Rebuttal to Tom Holbrook's Proof of Evidence (undated)

**Alpha House, Regis Road, Kentish Town
LONDON, NW5 3EW**

**Local Authority Ref:
2023/0093/P**

**The Planning Inspectorate Ref:
APP/X5210/W/24/3337347**

Photo of proposed southern route.

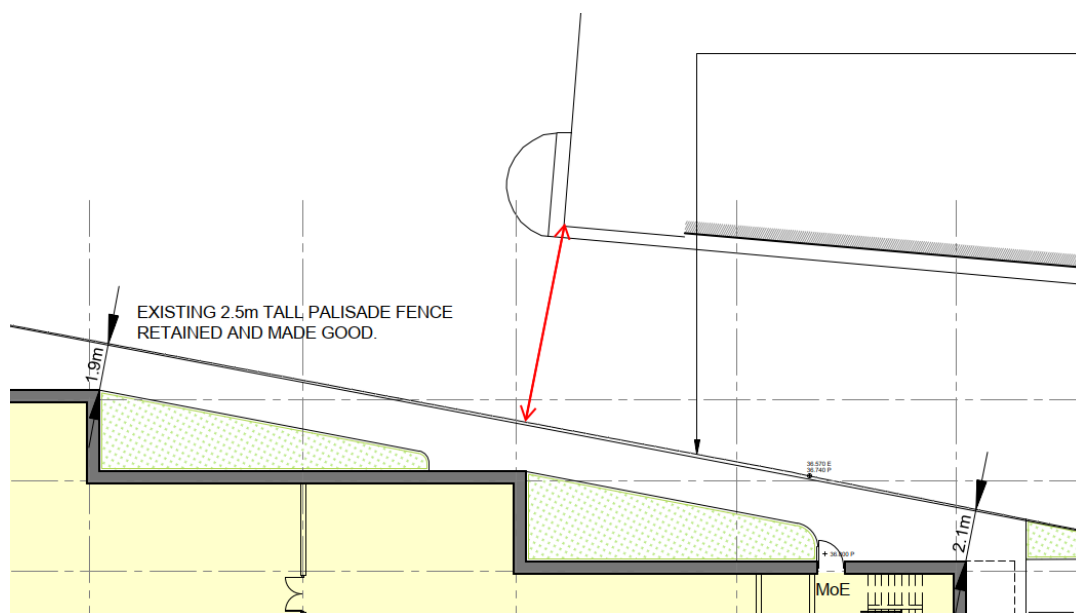
10. **TH 5.3 – 5.5, 7.2 and 7.9** discuss the potential creation of a new road, on land owned by UPS, to the south of the UPS building. Mr Holbrook suggests that this would be the optimal arrangement so as to separate industrial traffic from Regis Road. He claims that the northern (rear) elevation of the Appeal building would “**physically prevent**” the introduction of the road. This is not true.

12. Secondly, even if UPS was, for some reason, willing to convey this land to the Council, the Appeal building would not prevent the creation of such a road. Below is a photo of the land in which Mr Holbrook envisages this new access road.

13. Should UPS be willing to give up this land it is certainly wide enough to accommodate a new service road. However, there is a pinch point at the south west rear of the UPS buildings where the dimension between the building corner and Appel Site's fence is 8.2m. (See red dim line below).

14. Ideally an estate road would be 7.3m with a 2m footpath on at least one side (9.3m total required). To accommodate this, the rear security fence in the Appeal scheme could be removed so as to leave the building itself becoming as security line – (this has been done on previous BY projects). Adding the 1.9m maintenance strip to the 8.2m gap provides a total working width of 10.1m. Within that space one could provide a 2m footpath, a full width 7.3m carriageway and maintain 800mm clearance between the northern kerb line and the UPS building corner.

Extract showing the extent of Holmes Road healthy school street

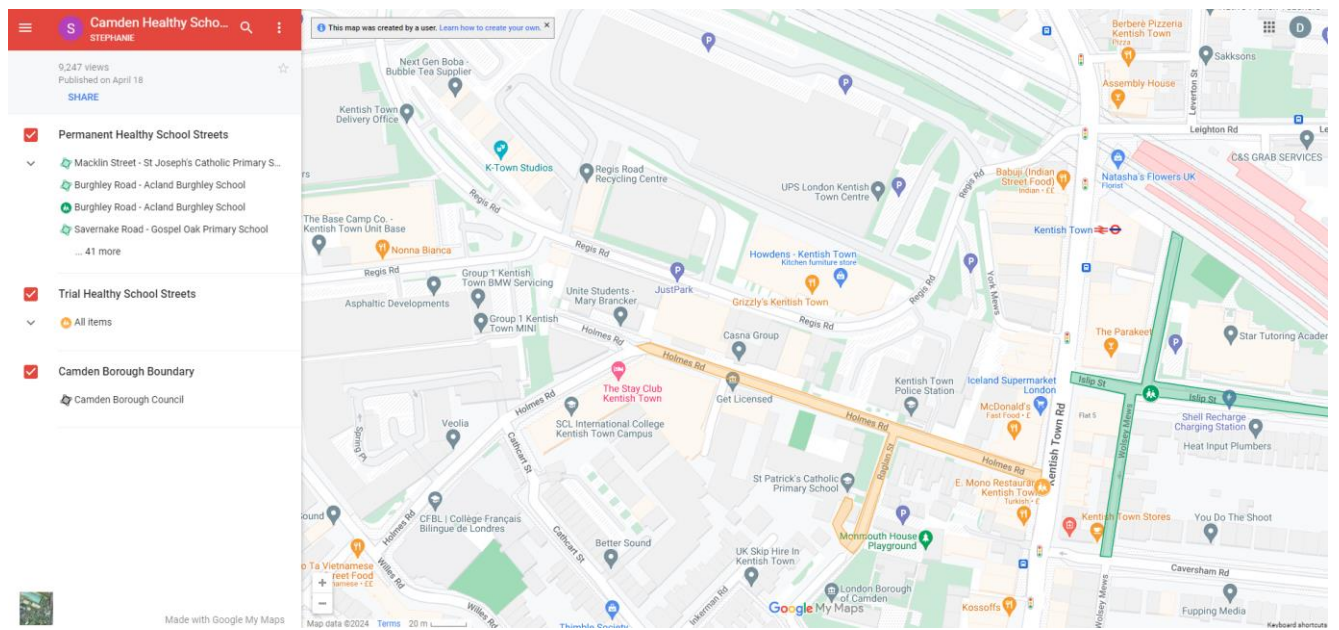
23. **TH 6.12** suggests LBC intend to make Holmes Road a ‘healthy school street’ preventing west bound traffic. Extracts from LBC’s website showing the extent of the Holmes Road healthy schools street, and an explanation of the scheme is appended to this rebuttal. This restriction would apply during school pick up and drop off times. The proposed new Holmes Road access is intended to serve only the few residents who have blue badge parking and would be exempt from the restriction – see list of exemptions in the appendix. The 5th Studio strategies also show vehicular use of Holmes Road, with a one-way system with vehicles entering via Spring Place and exiting onto Holmes Road. If preferred there would be nothing to prevent a similar traffic management approach being taken in the indicative masterplans.
